ULNRC- 04258

DOCKET NUMBER 50-483
UNION ELECTRIC COMPANY
CALLAWAY PLANT

REVISION TO TECHNICAL SPECIFICATIONS 3.3.2, 3.4.10, AND 3.4.11
PRESSURIZER SAFETY VALVES AND PORVS

M-761-C2018

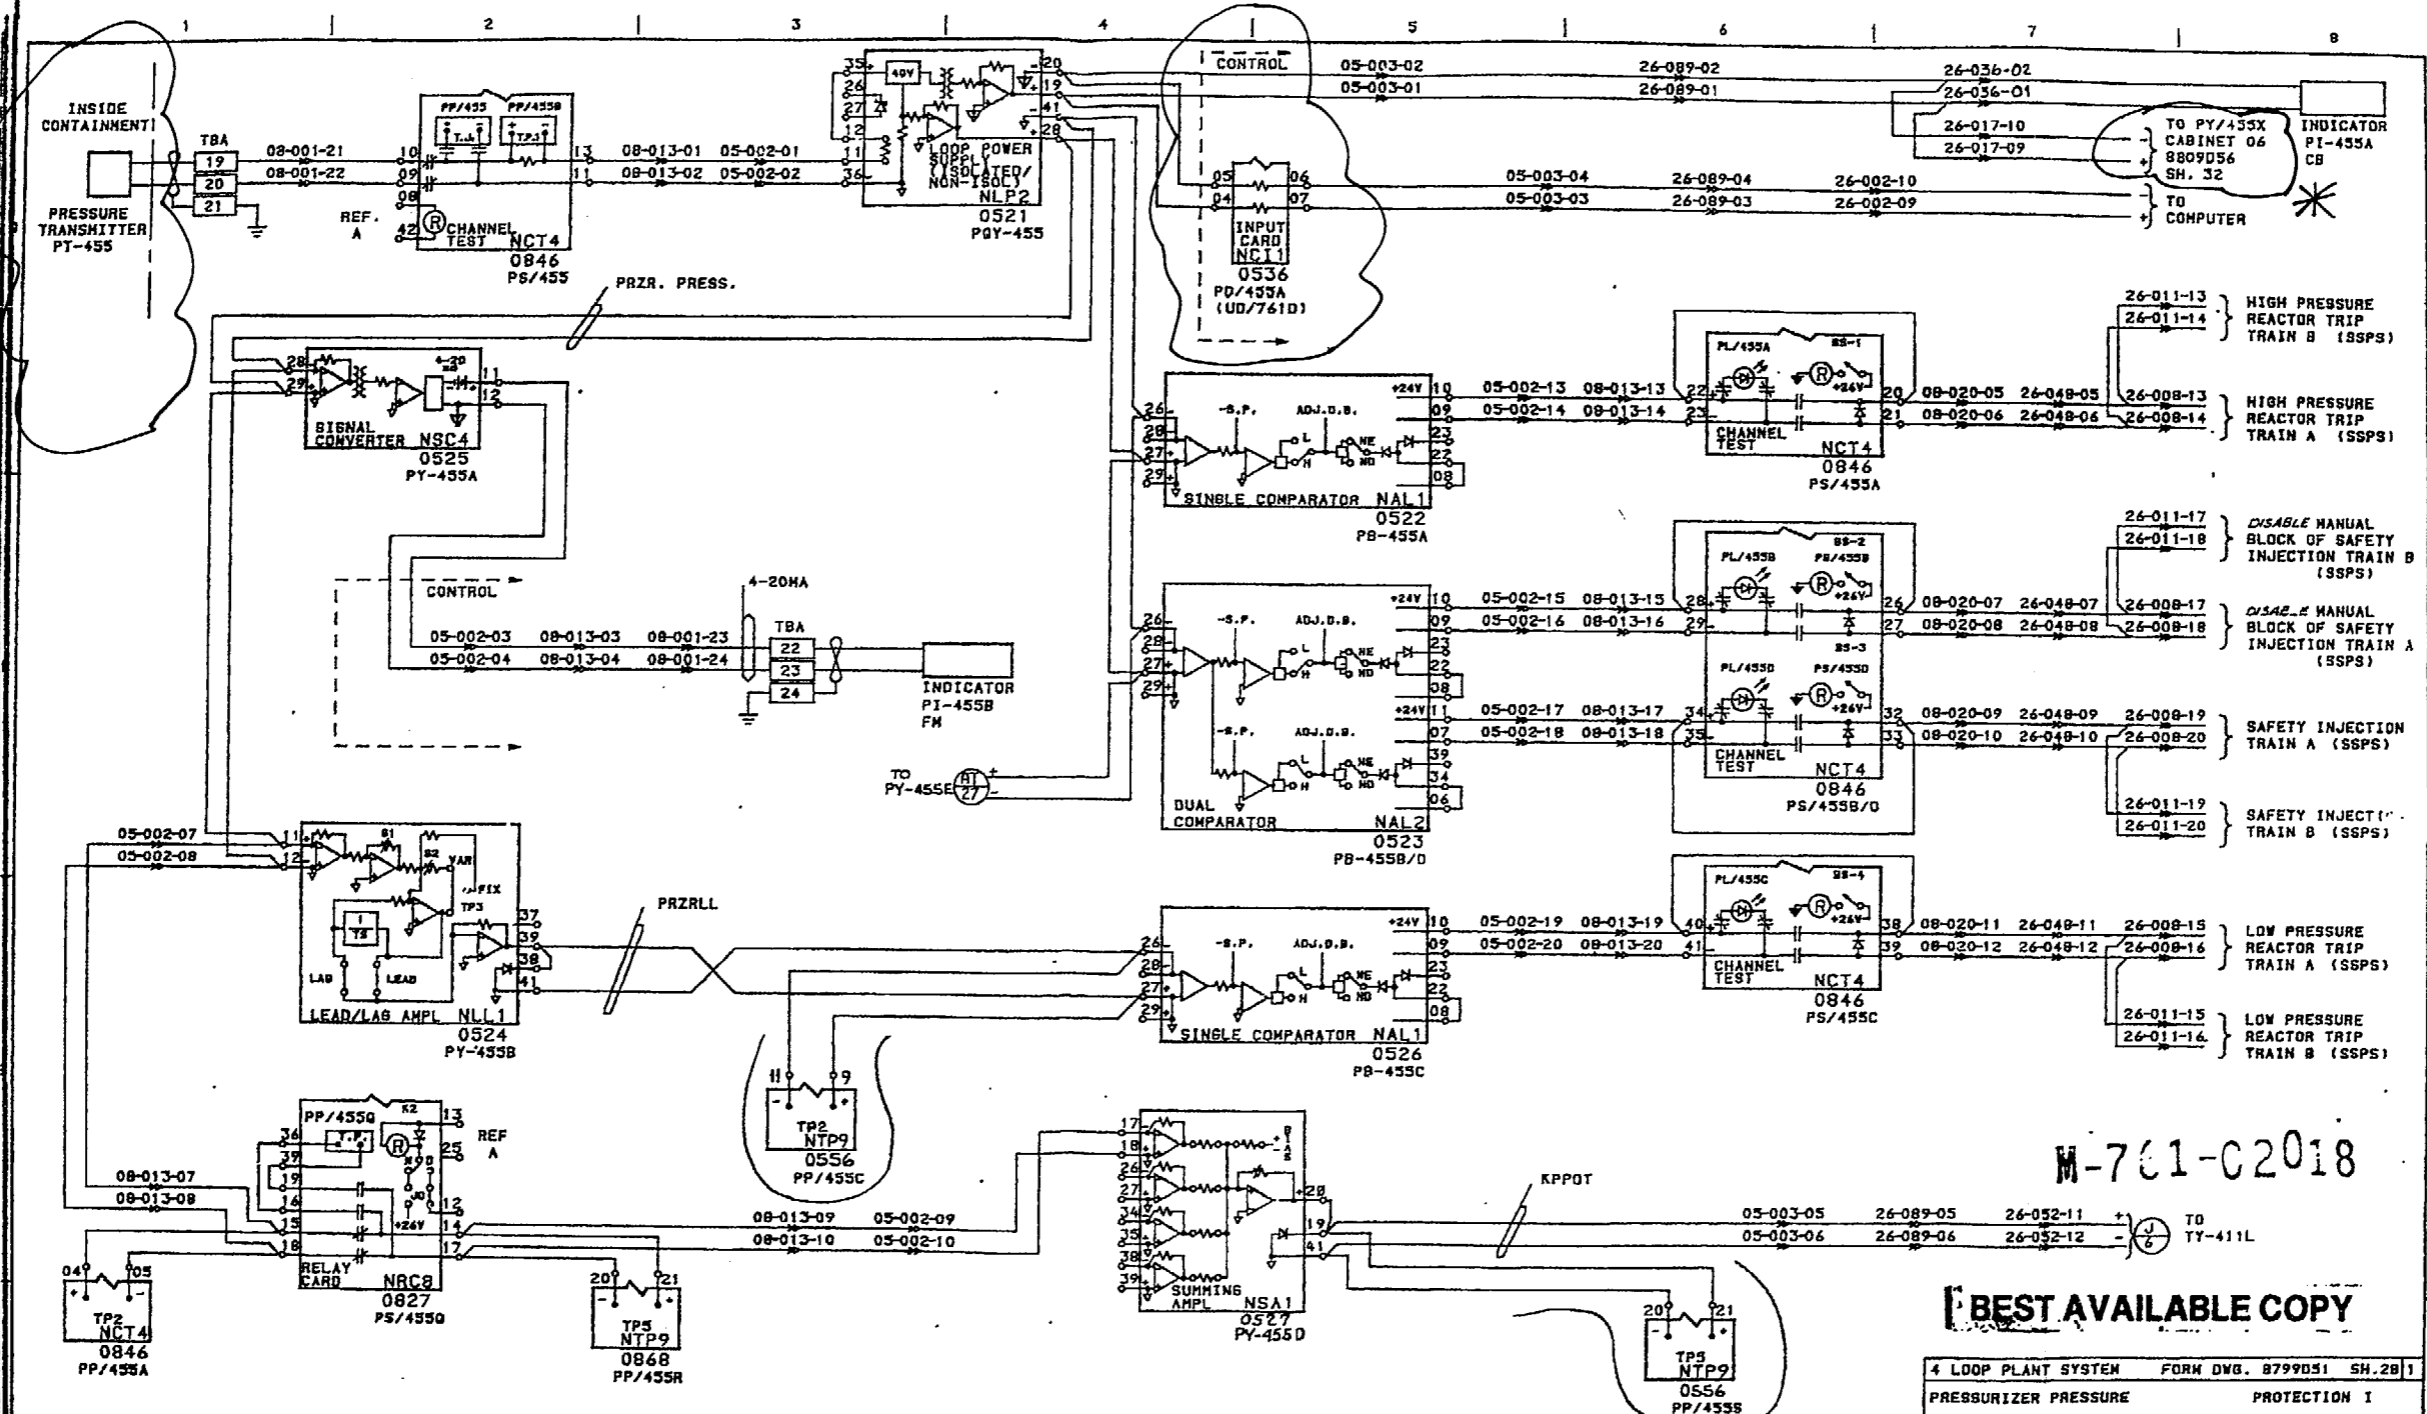
**(will be modified to fully Class I/E for automatic PORV actuation)*

M-761-02169 *

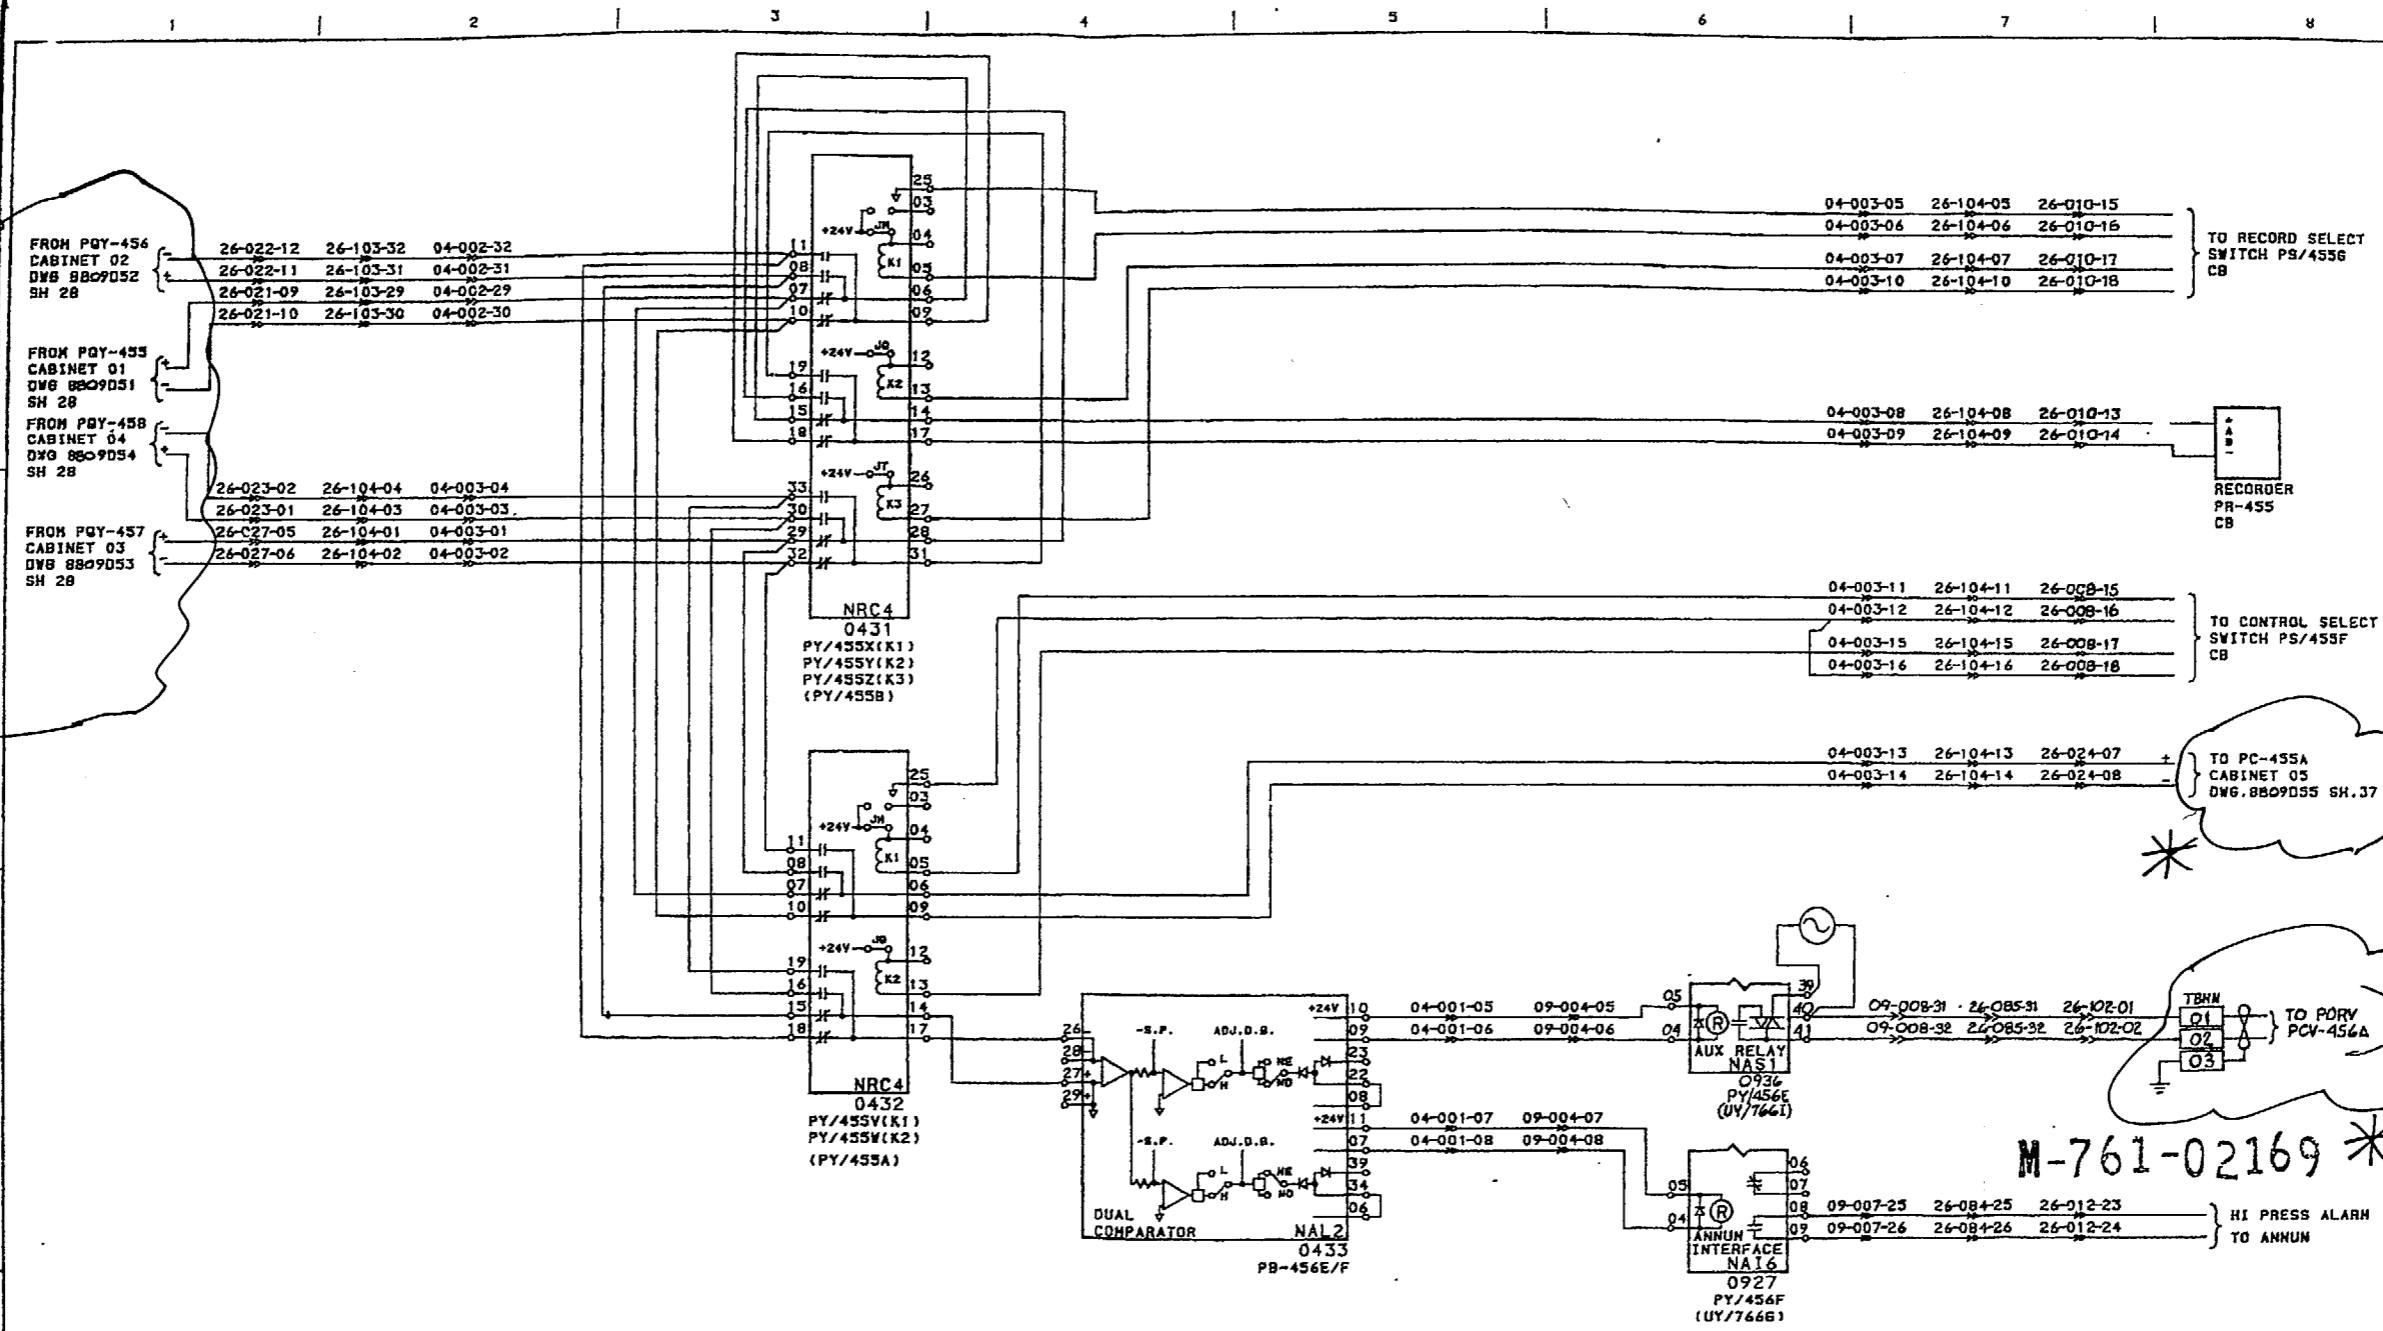
**(will be modified to fully Class 1E for automatic PORV actuation)*
